FINAL ENVIRONMENTAL IMPACT REPORT

10131 Constellation Boulevard

ENV-2004-6269-EIR

April 2006

NOTES:

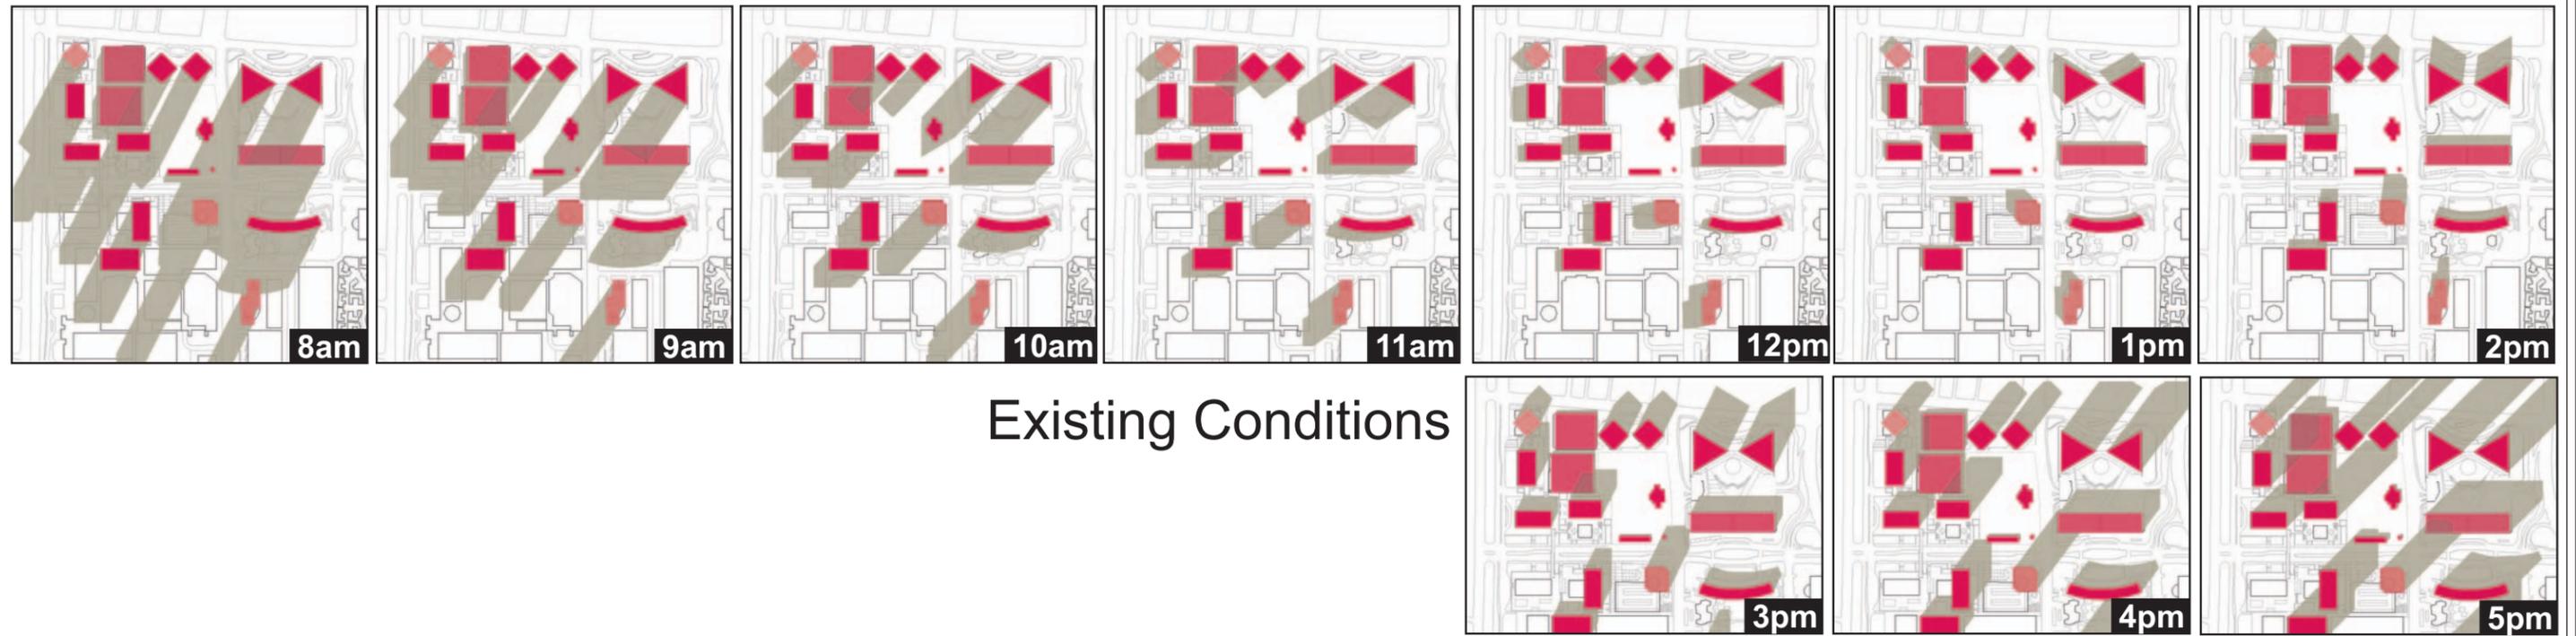
The exhibits depicting the Project's potential shade and shadow impacts under the various thresholds of significance depict multiple shadows at various times of the day in a single exhibit. As such, it is almost impossible to tell whether the thresholds are being exceeded due to the numerous overlapping shadows from various buildings during different time periods. The exhibits should be revised to depict a single time period.

The comment is noted and incorporated into the Final EIR for the review and consideration of the public and the City's decision makers prior to any approval action on the proposed Project. The shade/shadow simulations in Figures 45 through 52 of the Draft EIR clearly depict shadowing at specific hours of the day, corresponding to the times of day listed in the methodology for the shade/shadow analysis (Figures 45-52, Draft EIR, Section IV.C, page 252-261). The times of day shown in the figures are based on the intervals in which continuous shading would exceed threshold criteria. A single time period would not adequately show the potential for continuous shading according to the standards of the City CEQA Thresholds Guide and the CCNSP thresholds. The text of the shade/shadow analysis also explains what is occurring in the corresponding graphics. The revision of the shade/shadow graphics to show only a single time period would reduce the reader's understanding of the potential shade/shadow impact. Notwithstanding, the requested change in information is presented in Figure 10 through Figure 17 on pages 326 through 333 of this Final EIR.
